AMENDMENT NO. 1 AUGUST 2023
TO
IS 17566 : 2021 KEY LOCKS FOR SECURITY EQUIPMENT — SPECIFICATION

(Page 2, clause 5.4.3) — Substitute the following for existing:

FIG. 1 LEVER GATE AND KEYHOLE ARE NEARLY ALIGNED ($R \leq 1.5$)

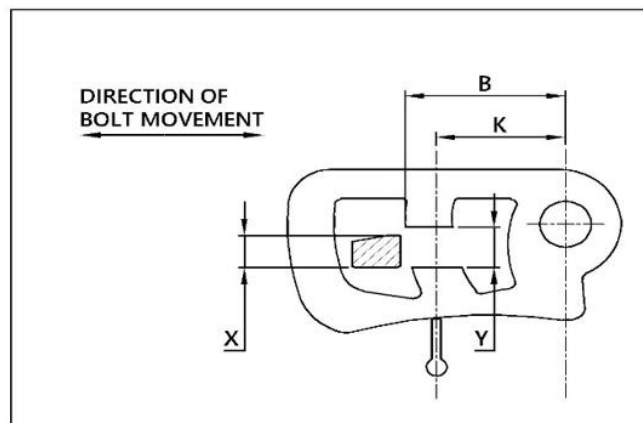
‘5.4.3 The difference between dimension ‘Y’ of gate of the lever and thickness ‘X’ of bolt stump in the direction perpendicular to bolt movement shall be specified as below.

5.4.3.1 In case of locks consisting of bolt stump and levers with linear gate, rotating about pivot pin, the following conditions shall apply:

- a) Difference (Y-X) shall not be more than 1 mm if $R \leq 1.5$; and
- b) Difference (Y-X) shall not be more than 2 mm if $R > 1.5$.

where

$R = B/K$;

B = Distance between centre of lever pivot axis and farthest edge of lever gate opening; and

K = Distance between centre of lever pivot axis and keyhole centre.
